**Charlottesville-Albemarle Metropolitan Planning Organization**

**Route 29 Bypass Design Advisory Committee**

**Criteria-Based Report on Proposed Design**

**Approved February 20, 1997**

Drawing 1: Ravine Near Proposed Bypass Location in Woodburn Road Area Submitted by Alex Dotson

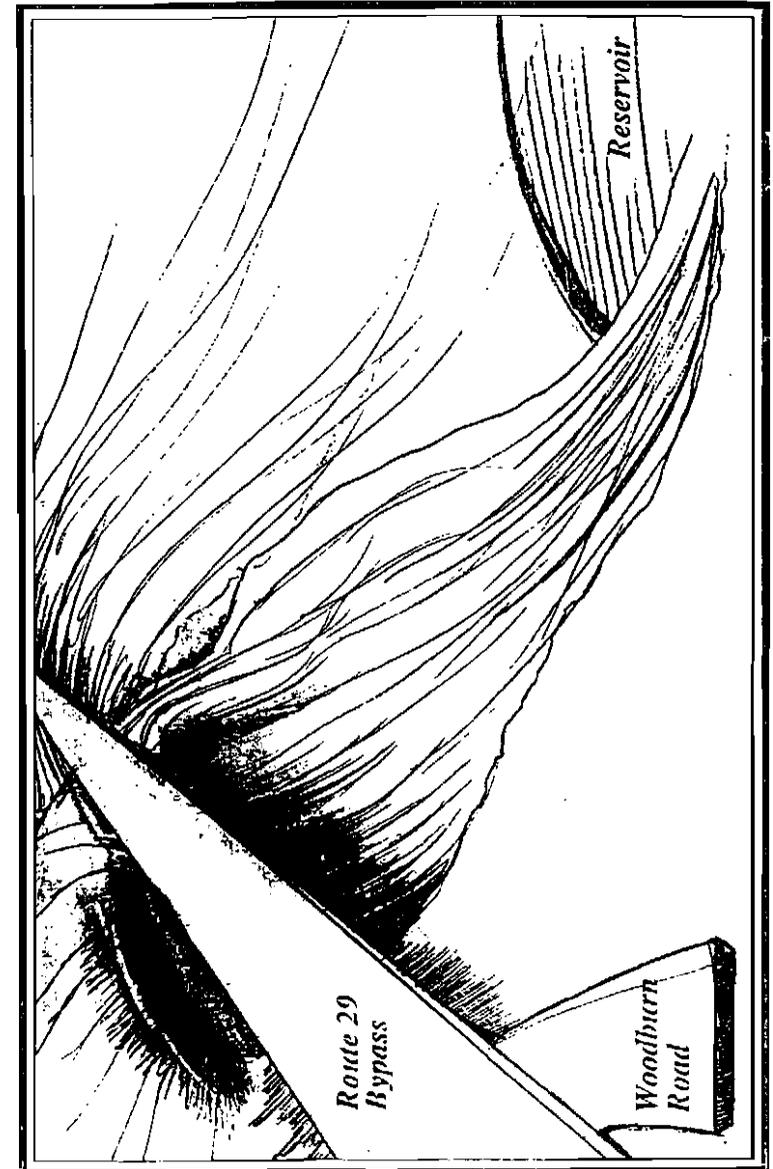
Although the proposed bypass passes through slightly more than four miles of watershed area, my primary concern is a quarter mile on Woodburn Road at Reservoir Ridge Road. Along this zone, the proposed bypass comes perilously close to the reservoir. Approximately 75 feet from the edge of the road surface, the land slopes at approximately 30 degrees; from 75 feet to about 150 feet the grade goes to approximately 45 degrees; from 150 feet to 375 feet is a sheer drop-off, or about an 80-degree slope (see drawings and photos at the end of this section).

It is quite obvious that sediment runoff, during construction, will be impossible to control. Our water supply will be completely contaminated within the first week of construction. In speaking with Mrs. Napier of VDOT, I was informed that they were only concerned with right of way areas and that this area between the right of way and the reservoir "did not matter."

*Proposed Rt. 29 Bypass  
Thomas Jefferson Planning District  
Depicts design defect in vicinity  
of Rivanna Reservoir  
Submitted: Feb. 20, 1997*

Drawing 2: Ravine Near Proposed Bypass Location in Woodburn Road Area  
Submitted by Alex Dotson

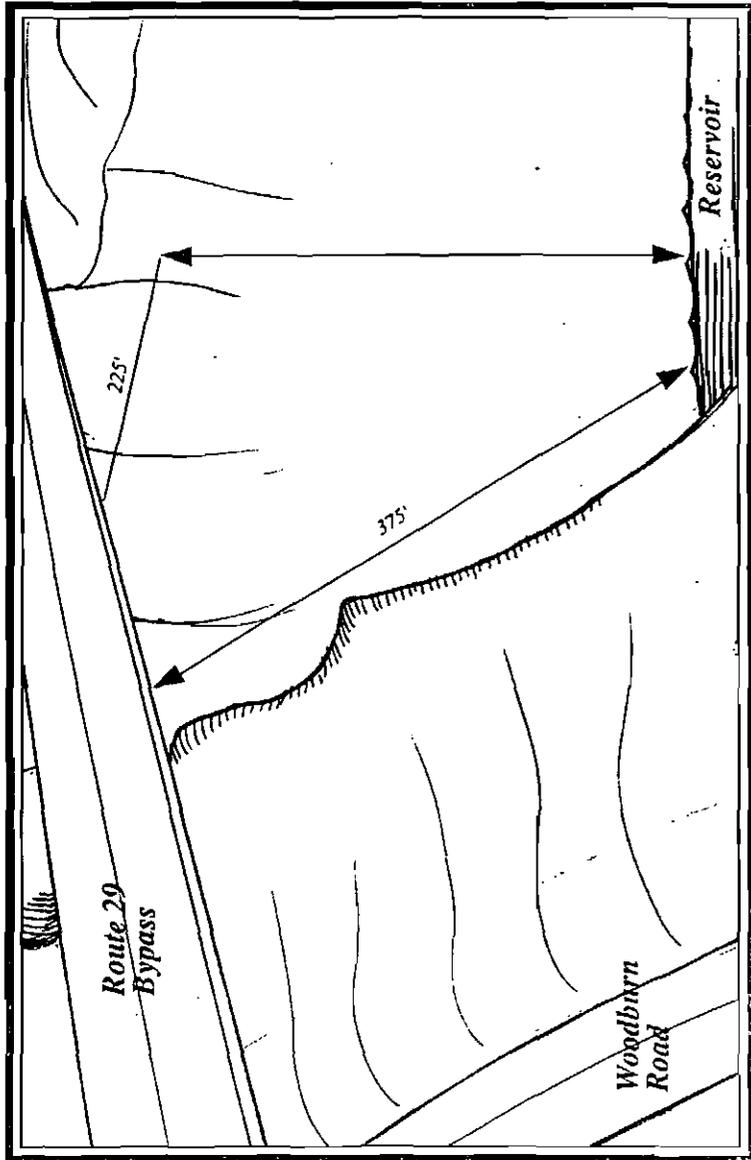
Proposed Rt. 29 Bypass  
Thomas Jefferson Planning District  
Depicts design defect in vicinity  
of Rivanna Reservoir  
Submitted: Feb. 20, 1997
